Re: Request to Amend Construction Permit No. AC 27-186923
Cement Kiln #1

RE: Florida Mining and Materials Brooksville Cement Kiln #1
Request for Permit Amendment, AC 27-186923

Re: Florida Mining & Materials Brooksville Cement Kiln #1 -
Request for Permit Amendment, Permit No. A027-213207

FM&M Kiln No. 1 Process Flow Diagram

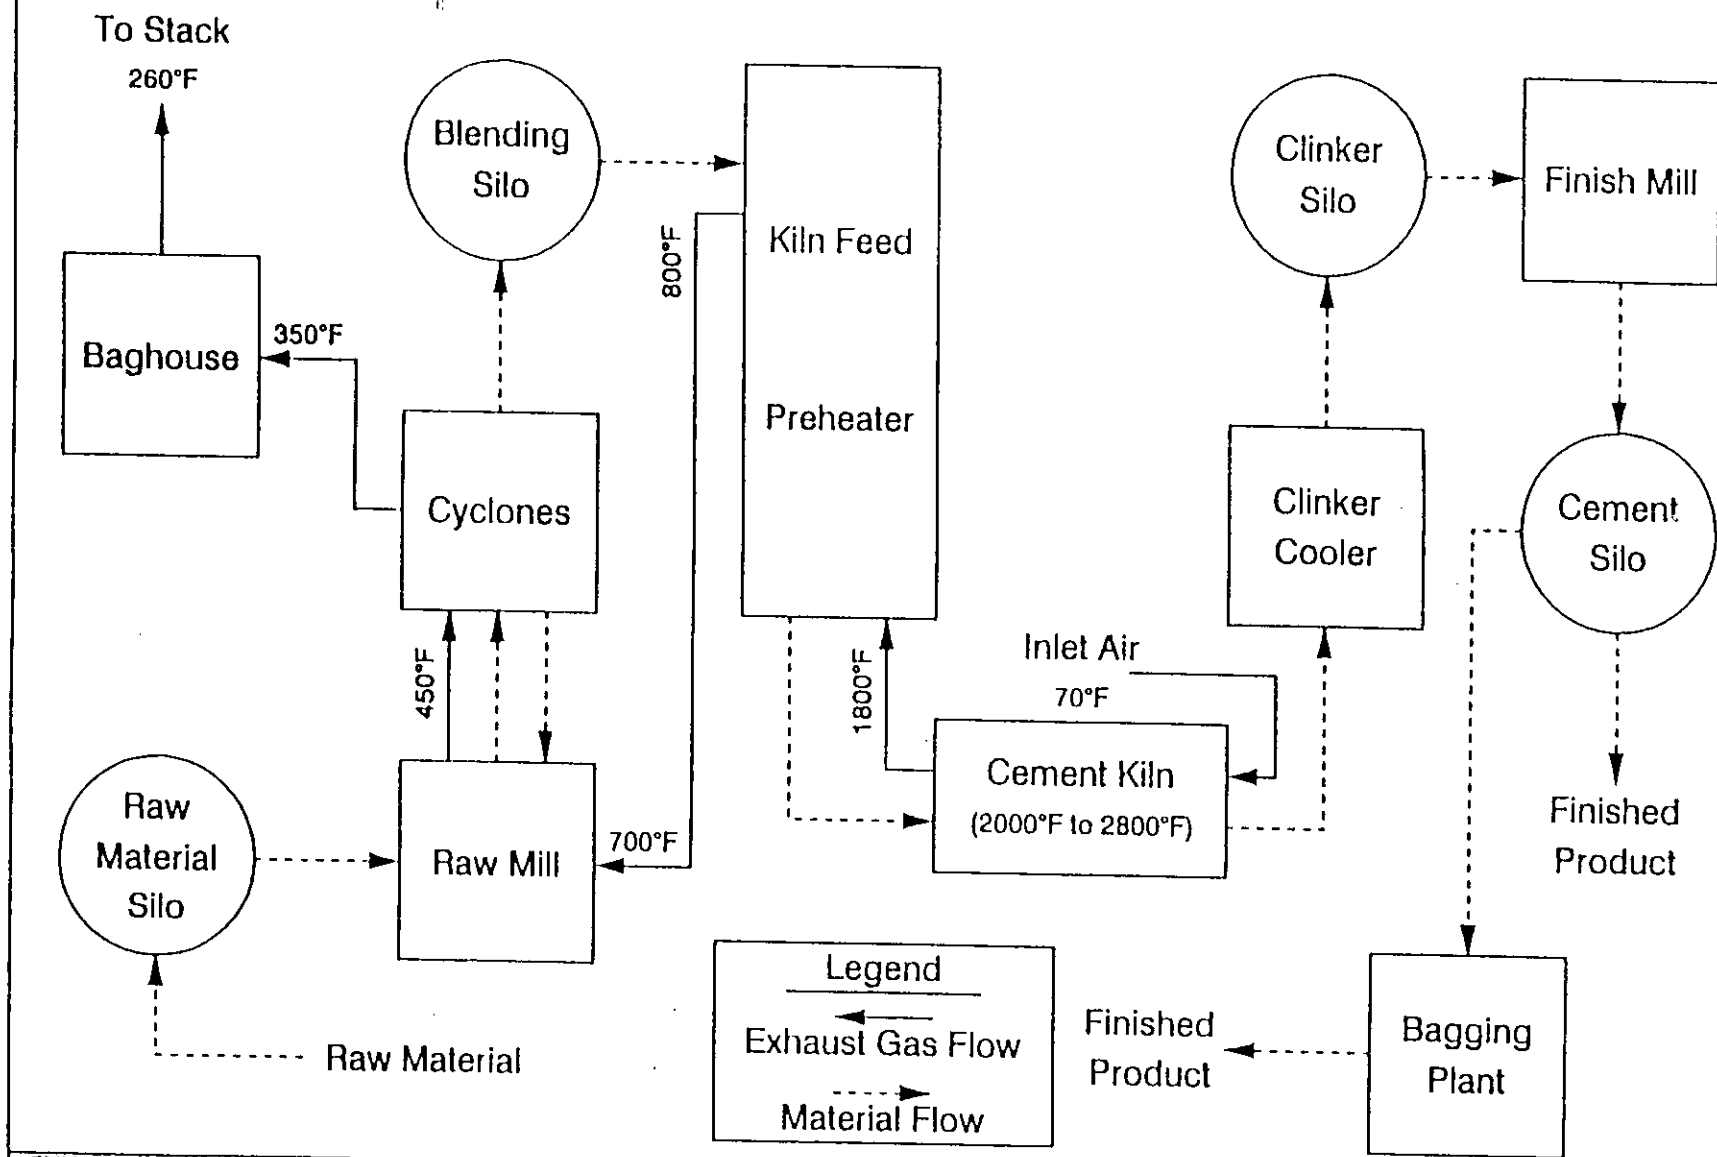
- o The #1 cement kiln is connected in series with the #1 clinker cooler, which is connected in series with the #1 clinker storage silos. Since it appears that the #1 CPLHS is not connected to the #2 CPLHS, except for the raw material feed into the raw mills, then the #1 clinker cooler and other #1 auxiliary sources do not receive clinker product without their #1 cement kiln operating.

- o It is apparent that there is an incompatibility between the the permitted operation capacities of the #1 cement kiln and its associated clinker storage silos (i.e., 79.9 vs. 84 tons/hr). As stated before, the operation of the #1 clinker cooler and the associated #1 clinker storage silos depend on the product output of the #1 cement kiln.

Since the product yield of the #1 cement kiln is the factor used in estimating the potential pollutant emissions for it and associated sources operating in series with it, the Department cannot justify deleting the federally enforceable condition establishing the allowable maximum clinker product of the #1 cement kiln. However, if an increase in the clinker product is desired, then an application for a modification shall be submitted along with the appropriate processing fee to the Department's Bureau of Air Regulation office.
